Access Compliance Report Public Rights-of-Way (Curb Ramps)

Intersection ID: 44118 Main Street: CORAM PL **Cross Street: RIDING HILL AV** Location: Ε **ADA ID: A918B4E8E6FE** Ramp Type: PerpDiag Initial Pass/Fail: Fail **Overall Compliance: No Severity Score:** 10

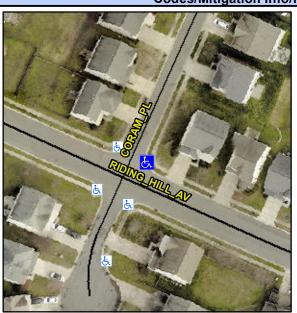
Possible Solutions: Remove & Replace Curb Ramp With **Two New Directional Ramps or** Equivalent. Surveyor Notes: N/A PROW/ADA: Not Found, R304.5.1, R304.5.3

Field Measurements/Component Compliance					
Compliance Description		Data	Comp	liance Description	Data
N/A	Ramp Length (in)	48.0	Yes	Ramp Slope (%)	5.9
No	Ramp Width (in)	37.0	No	Ramp XSlope (%)	2.2
N/A	Flare Type LT	N/A	N/A	Flare Type RT	N/A
N/A	Flare Slope LT (%)	N/A	N/A	Flare Slope RT (%)	N/A
N/A	Flare Traversable LT?	N/A	N/A	Flare Traversable RT?	N/A
N/A	Landing Length (in)	N/A	N/A	DWS Provided?	N/A
N/A	Landing Width (in)	N/A	N/A	DWS Contrast?	N/A
N/A	Landing Slope (%)	N/A	N/A	DWS Length (in)	N/A
N/A	Landing X Slope (%)	N/A	N/A	DWS Full Width?	N/A
N/A	Landing Curb? (Y/N)	N/A	N/A	DWS Offset (in)	N/A
N/A	Shared Landing?	N/A			
N/A	Gutter Ponding?	N/A	N/A	Gutter Slope (%)	N/A
N/A	Gutter Lip Ht (in)	N/A	N/A	Gutter X Slope (%)	N/A
N/A	Painted X Walk1?	No	N/A	Painted X Walk2?	No
	X Walk 1 Direction	To NW		X Walk 2 Direction	To SW
N/A	X Walk 1 Width (in)	N/A	N/A	X Walk 2 Width (in)	N/A
	X Walk 1 Slope (%)	5.2		X Walk 2 Slope (%)	2.8
